# Access Compliance Report

## Public Rights-of-Way

### (Curb Ramps)

Intersection ID: 45220	Main Street: ARDREY_KELL_RD	Cross Street: HARCOTBE_DR	Location: SE
ADA ID: 821DE2D3D083	Ramp Type: Perp	Initial Pass/Fail: Fail	Overall Compliance: No
		Severity Score: 12.5

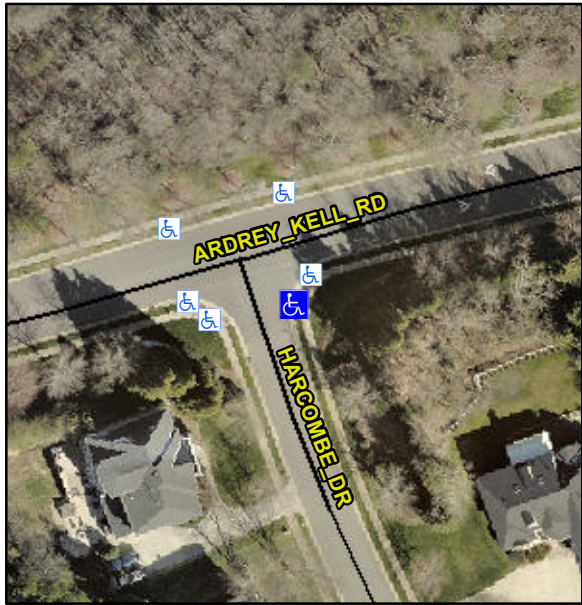
Codes/Mitigation Info/Possible Solution			Field Measurements/Component Compliance					
	Possible Solutions:		<b>Compliance</b>	<b>Description</b>	<b>Data</b>	<b>Compliance</b>	<b>Description</b>	<b>Data</b>
	<b>Remove &amp; Replace Entire Ramp.</b>		N/A	Ramp Length (in)	49.0	No	Ramp Slope (%)	9.0
			Yes	Ramp Width (in)	48.0	Yes	Ramp XSlope (%)	1.9
			N/A	Flare Type LT	N/A	N/A	Flare Type RT	N/A
			N/A	Flare Slope LT (%)	N/A	N/A	Flare Slope RT (%)	N/A
			N/A	Flare Traversable LT?	N/A	N/A	Flare Traversable RT?	N/A
			N/A	Landing Length (in)	N/A	N/A	DWS Provided?	N/A
			N/A	Landing Width (in)	N/A	N/A	DWS Contrast?	N/A
			N/A	Landing Slope (%)	N/A	N/A	DWS Length (in)	N/A
			N/A	Landing X Slope (%)	N/A	N/A	DWS Full Width?	N/A
Surveyor Notes:			N/A	Landing Curb? (Y/N)	N/A	N/A	DWS Offset (in)	N/A
PROW/ADA:			N/A	Shared Landing?	N/A			
<b>Not Found, R304.2.2</b>			N/A	Gutter Ponding?	N/A	N/A	Gutter Slope (%)	N/A

N/A	Gutter Lip Ht (in)	N/A	N/A	Gutter X Slope (%)	N/A
			N/A	Painted X Walk1?	No	N/A	Painted X Walk2?	N/A
				X Walk 1 Direction	To W		X Walk 2 Direction	N/A
			N/A	X Walk 1 Width (in)	N/A	N/A	X Walk 2 Width (in)	N/A
				X Walk 1 Slope (%)	0.8		X Walk 2 Slope (%)	N/A
				X Walk 1 X Slope (%)	2.3		X Walk 2 X Slope (%)	N/A
			N/A	Ramp inside XWalk1?	N/A	N/A	Ramp inside XWalk2?	N/A
				Road Slope (%)	N/A	N/A	Clear Space?	N/A
				Road X Slope (%)	N/A	N/A	Clear Space to XWalk (in)	N/A
			N/A	Any Obstructions?	N/A	N/A	Storm Grate/Utility Hazard?	N/A
				Obstruction Type			Storm Grate/Utility Type	
					N/A			N/A
						Yes	Surface Condition? (G/P)	Good
Total Cost:		\$	1850.00					
Street 1 Name		HARCOMBE DR						
Stop Condition-Street 2		StopSign						
Street 2 Name		N/A						
Stop Condition-Street 1		N/A
